ADDENDUM #01

TO CONTRACT DOCUMENTS FOR: PROJECT #CP250051 – Agriculture Engineering Building – Rms 164/166 Fermentation Lab Renovation

PREPARED FOR: The Curators of the University of Missouri

CONSULTANT: Planning, Design & Construction
University of Missouri
130 General Services Building
(573) 882-6800

LEVEL 02 DEMOLITION PLAN - PLUMBING | R5
SCALE: 1/8" = 1'-0"

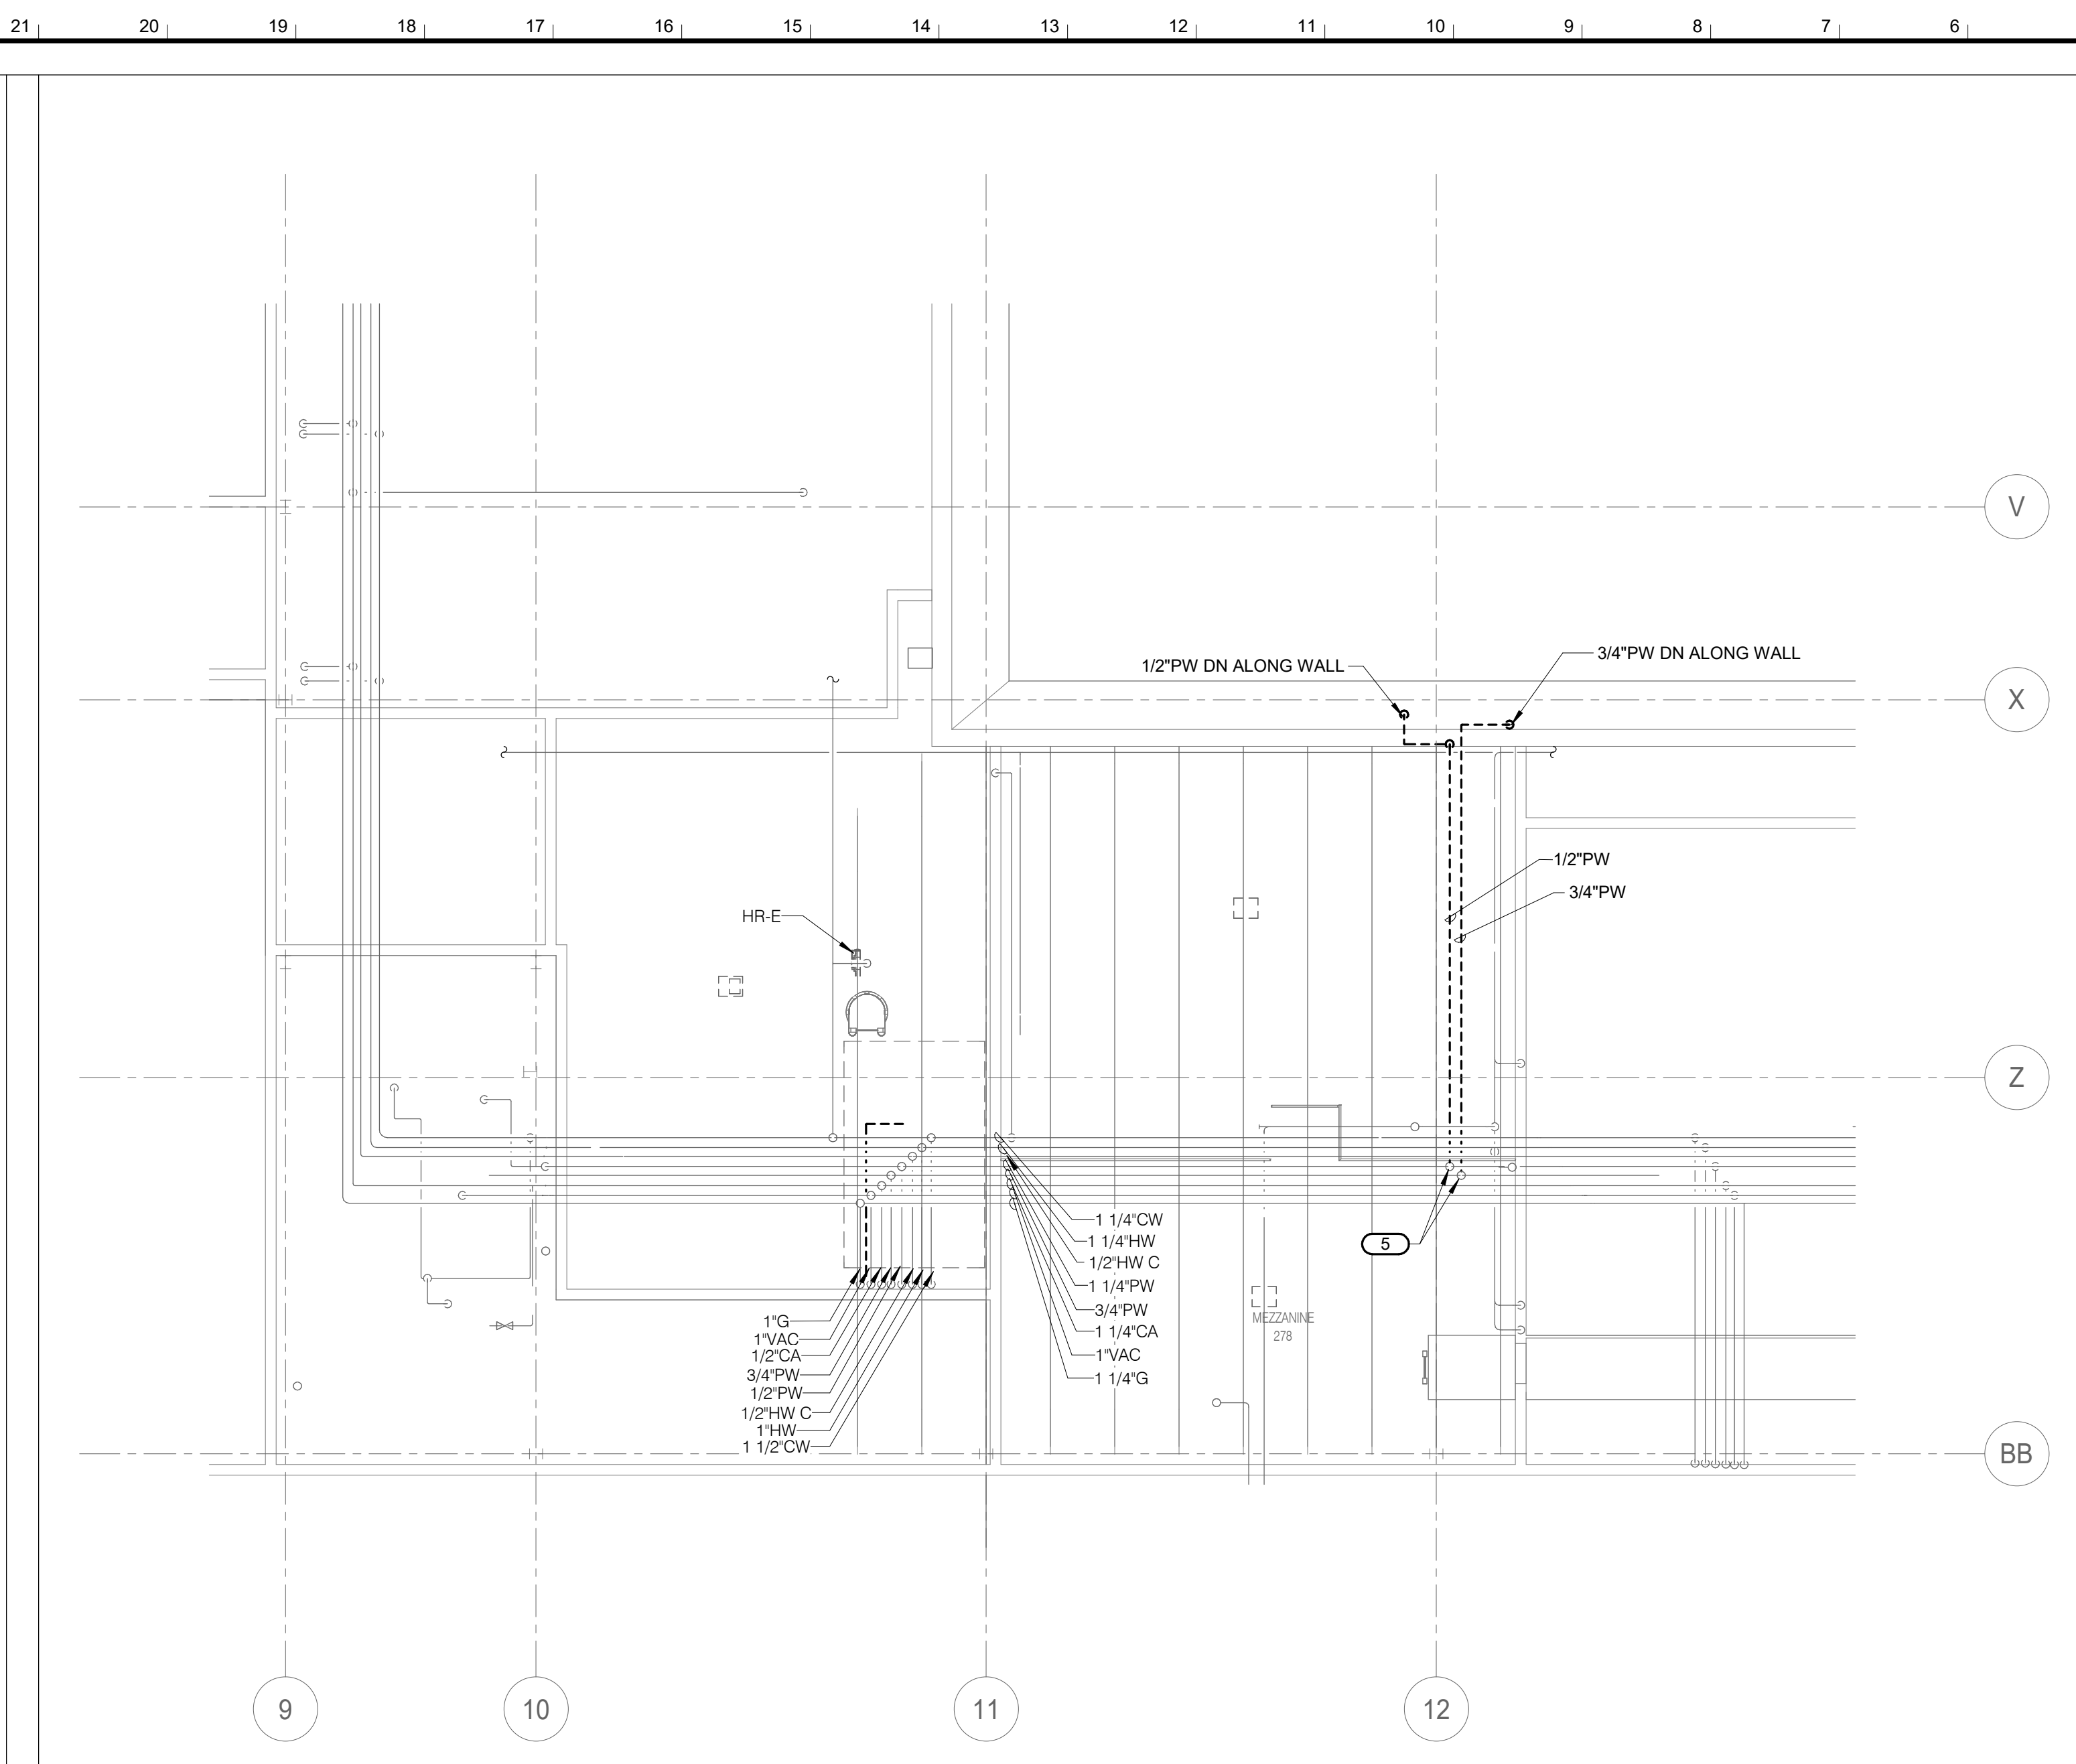
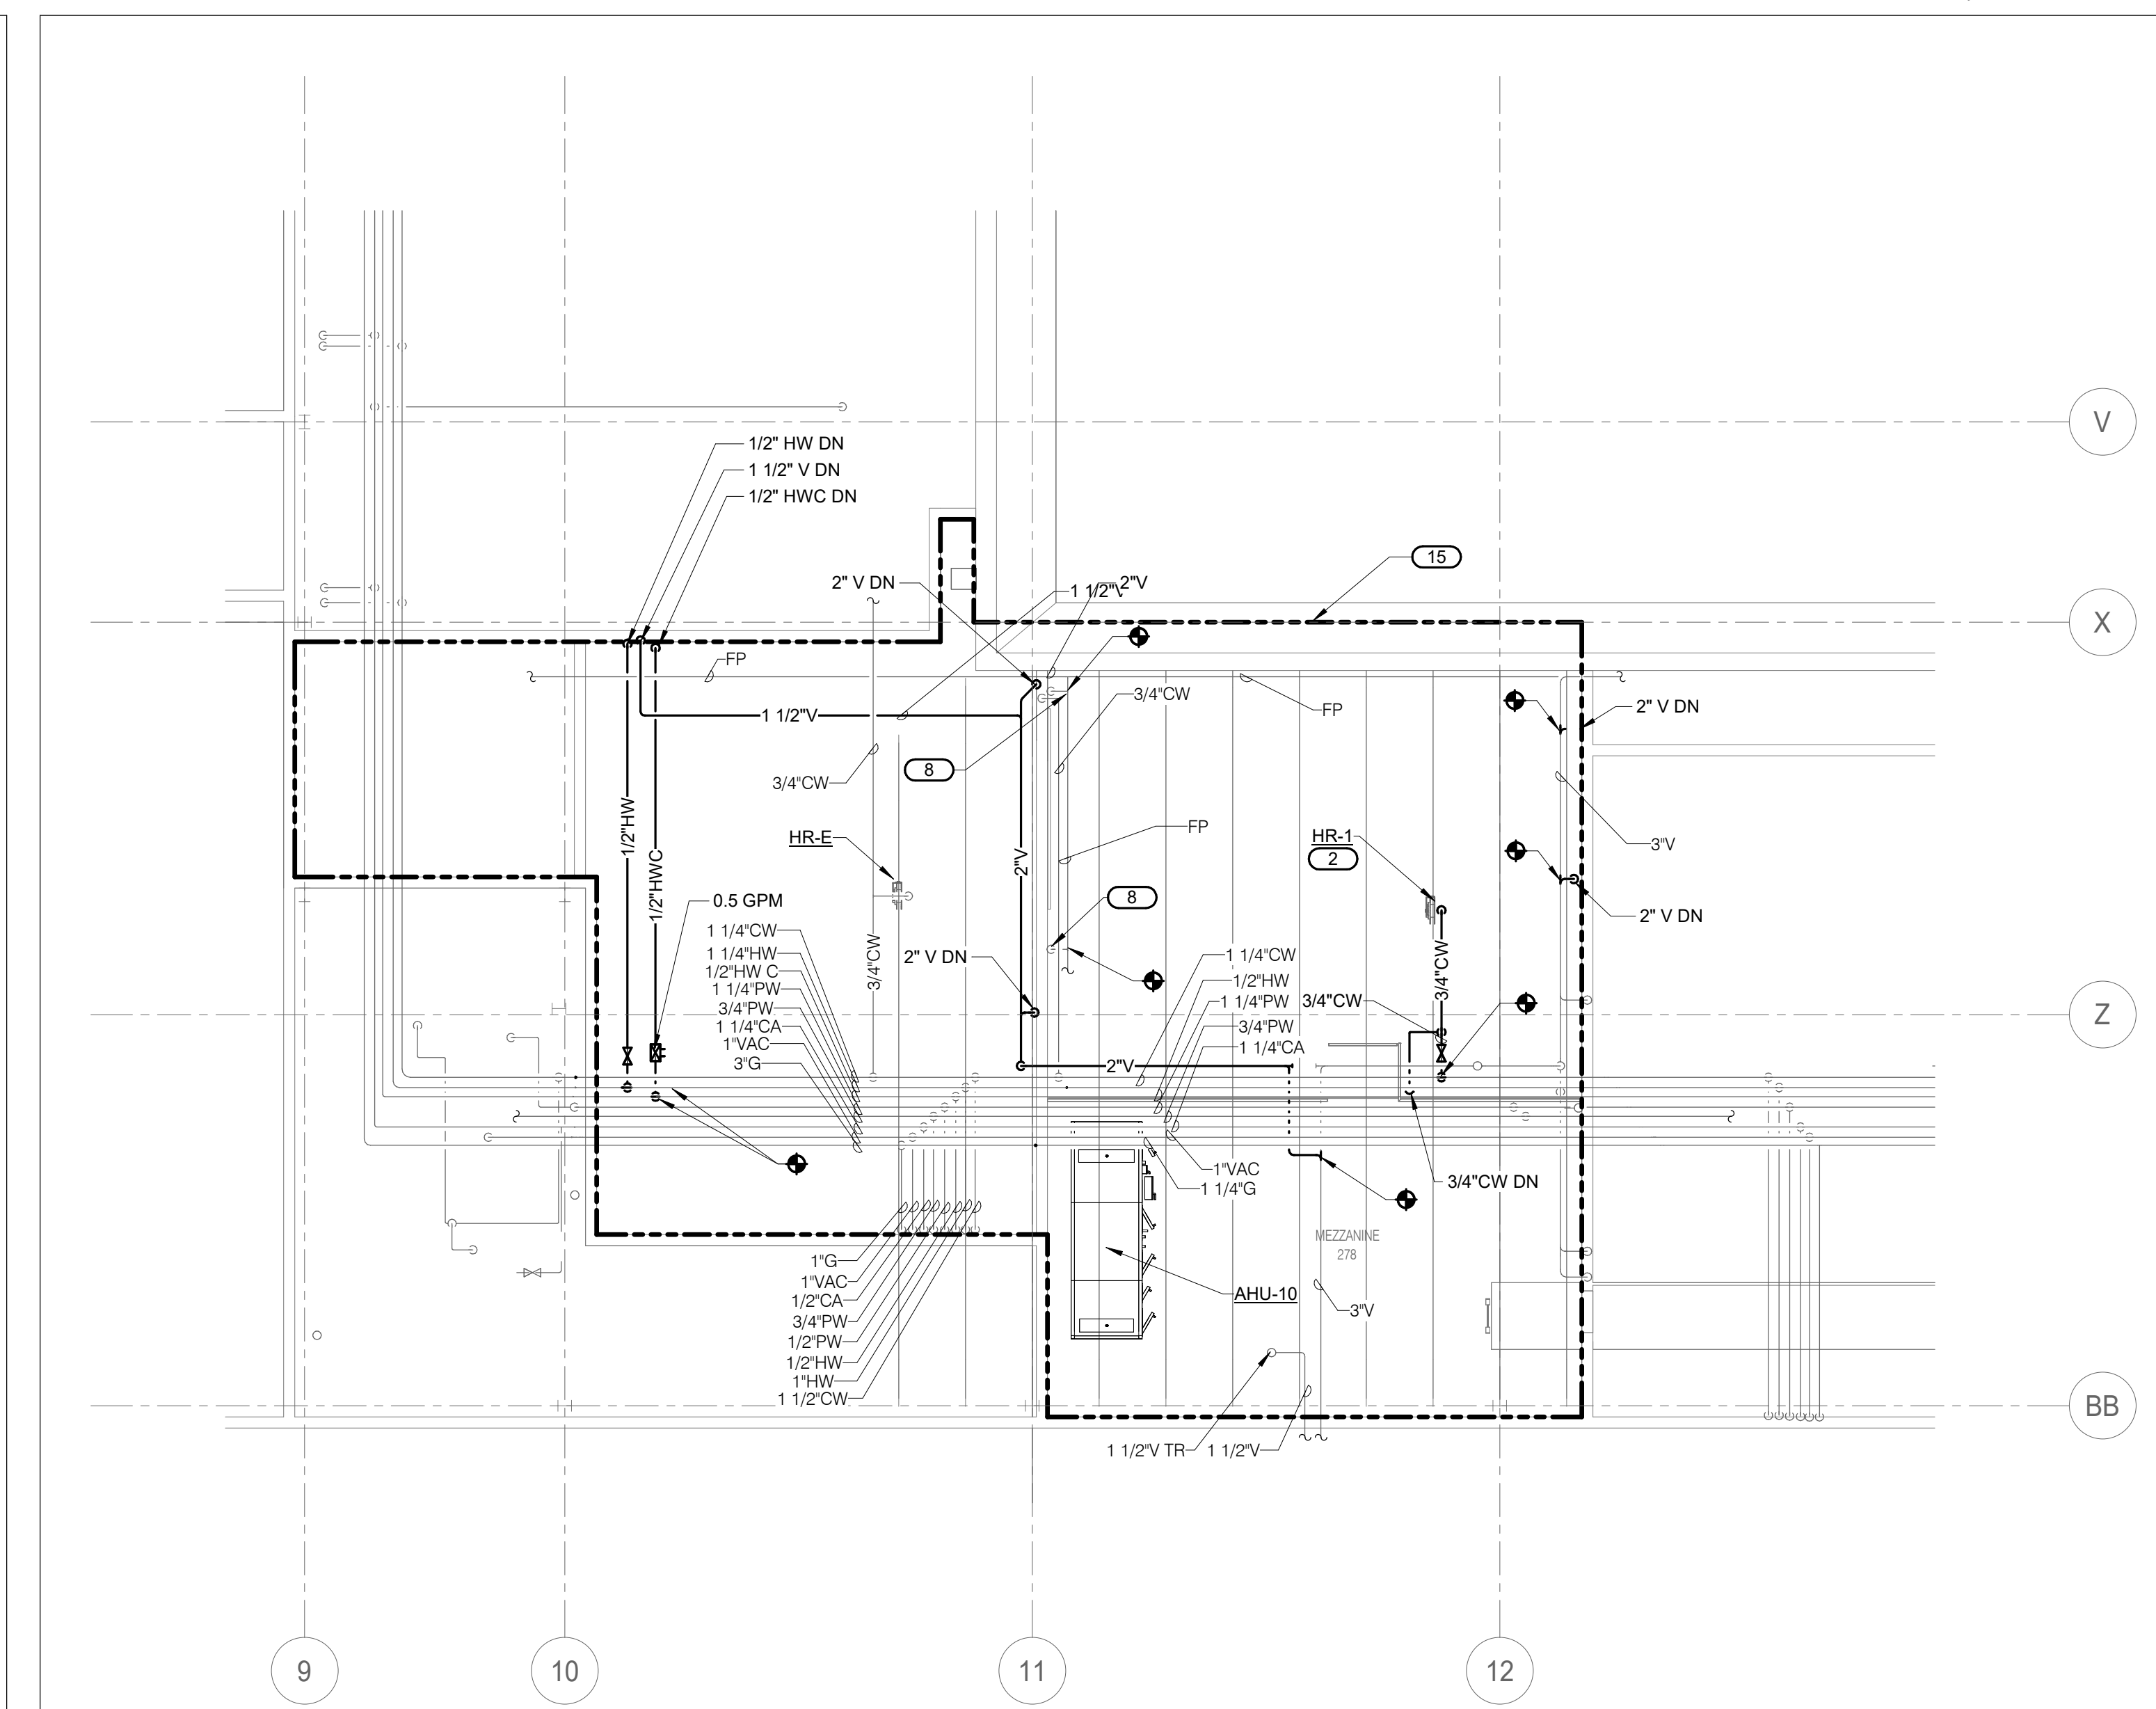
CLARIFICATION: Removed existing floor drain in Room 168.
Demo piping and note added in Room 168.
Revised Keynote 1 with added existing drain information.
New Keynote 18.
Added FS-1 tag in Room 168.

- KEYNOTES:**
- EXISTING JOSAM 3000A FLOOR DRAIN GRATE TO BE REPLACED WITH 3/16 STAINLESS STEEL FULL GRATE WITH 1/2" SQUARE OPENINGS.
 - STEEL STRUCTURE AT APPROX. 27'8" AFT. COORDINATE LOCATION WITH ARCHITECT PRIOR TO INSTALLATION.

- REMOVE FLOOR DRAIN, GRATE, AND PIPING NOT REQUIRED TO REMAIN.
 - REMOVE EXISTING PIPING UP TO THE POINT OF CONNECTION TO MAINS. CAP CONNECTION POINT.
